TECHNICAL SERVICE BULLETIN

Non-Shelby GT-350 - Various Concerns With The Active Exhaust System

25-2146

10 April 2025

Figure 1 - Exhaust clamp locking tabs.

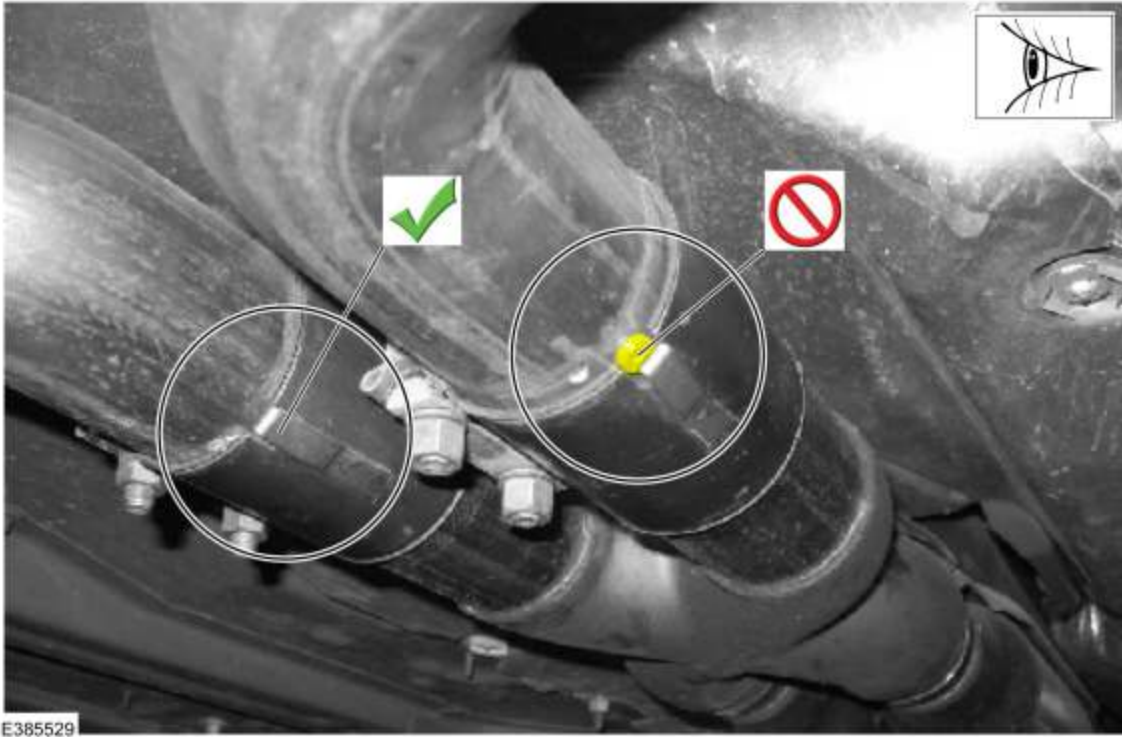
5. Inspect the muffler and tailpipe assembly and both catalytic converters for proper positioning of the exhaust clamps securing them together. Make sure the exhaust clamp locking tab is fully engaged to the catalytic converters (Refer to Figure 1). Make sure the knurled/ridge area of the muffler and tailpipe assembly are covered

by the exhaust clamps (Refer to Figures 2-3). Adjustments can be made by loosening the exhaust clamps and repositioning the muffler and tailpipe assembly. (Figures 1-3)
